SBN - 420
TF B7.1.2

Subject: Additional Information On Open Items - Power System Branch
(Electrical)

OPEN ITEM 17

Figure 430.53

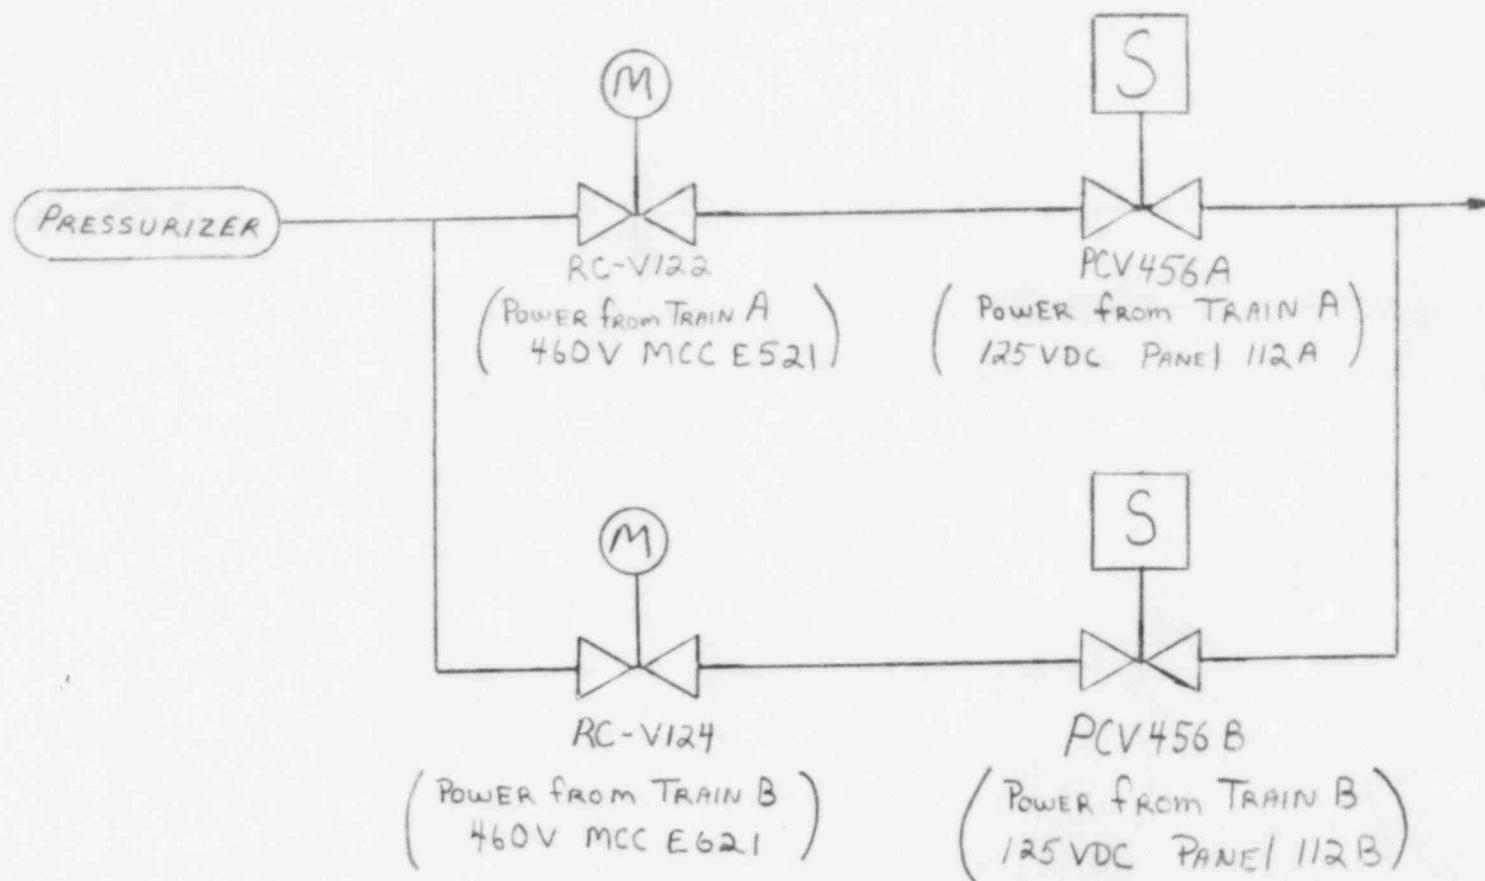
430.53 Describe how the Seabrook design complies with the guidelines of NUREG-0737, Items II.E.3.1 and II.G.1.

The design of the PORV block valves provides the capability to close the valves and retains to the extent practical the capability to open the valves.

These capabilities are maintained by providing two redundant motor-operated PORV block valves located in parallel flow paths. One PORV block valve is supplied power from the Train A emergency bus and the other PORV block valve is supplied power by the Train B emergency bus.

The motive and control power for the block valves is from a different emergency bus from the source supplying the PORVs. See Figure 430.53.
